SUBJECT: REQUEST FOR TECHNICAL ASSISTANCE

Per your request dated June 28, 1983, we have reviewed the information submitted to the State of Maryland by Neutron Products, Inc. We understand that Neutron Products, Inc. proposes to manufacture and commercially distribute these Cobalt-60 sources.

This letter requests a modification to the subject Certificate of Compliance to allow Neutron Products to utilize the G.E. Model 700 shipping package to ship cobalt-60 from the Savannah River plant to Neutron Products' Dickerson, Maryland facility.

FIG. 5.4.1.1

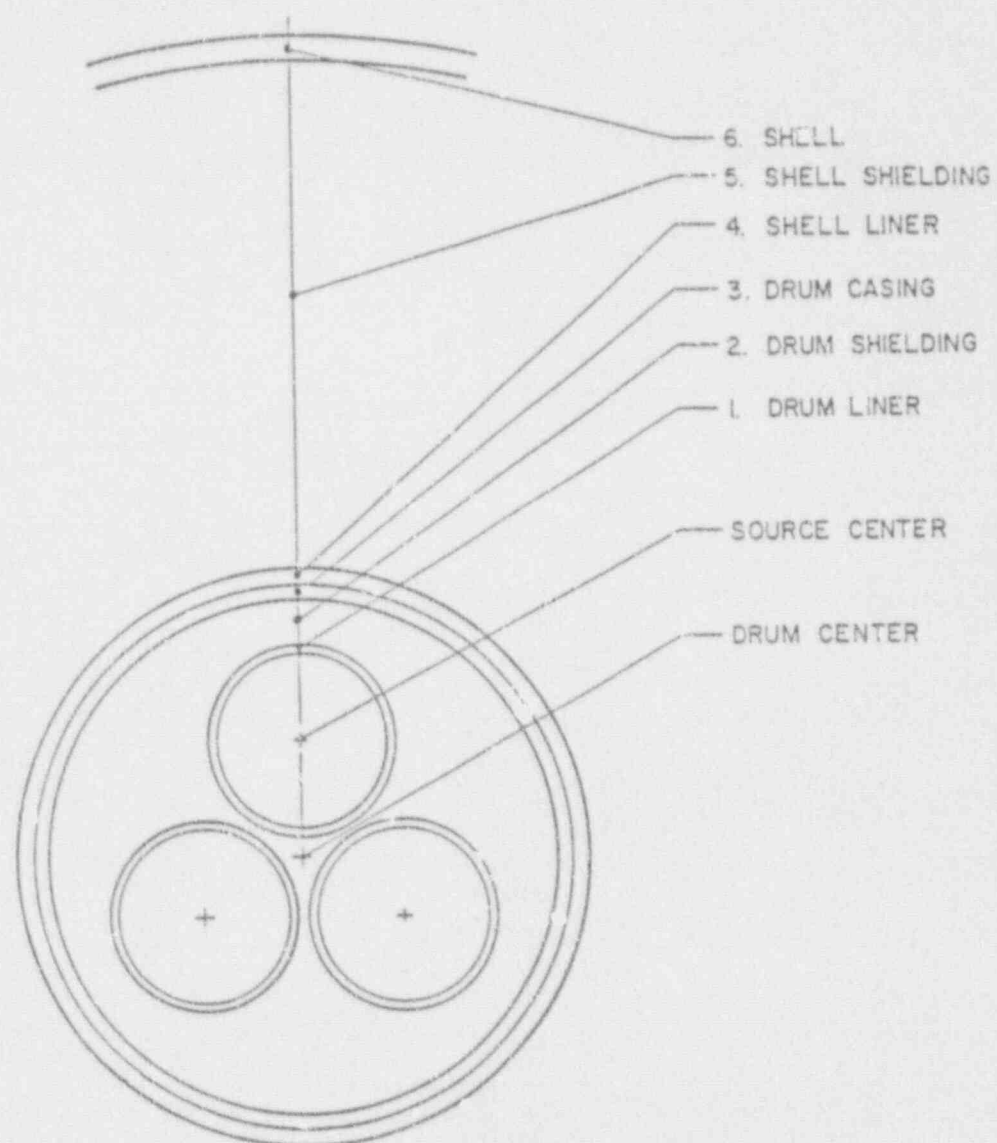
The application should provide sketches with the appropriate dimensions and materials and the shielding calculations in support of the descriptions and statements both for the normal and accident conditions.

Table 5.4.1.1 lists the input parameters for the calculation, as well as the results. The configuration is shown schematically in Figure 5.4.1.1. The constituent material attenuations are shown for each of the shielding component materials, as well as the total for both the original and new inner containers. The ratio of the new to the original cask attenuation is 1.54. Looked at in another way, for the same surface dose, the new cask would have to contain a source strength 54 percent greater. The original inner container was not considered shielding limited at 9,500 curies, so that no absolute level of source strength can be determined by this means; however, when applied to actual package measurements, such as those shown in Table 5.1.1, the package dose rates with a 15,000 curie source could easily meet normal shipping requirements.
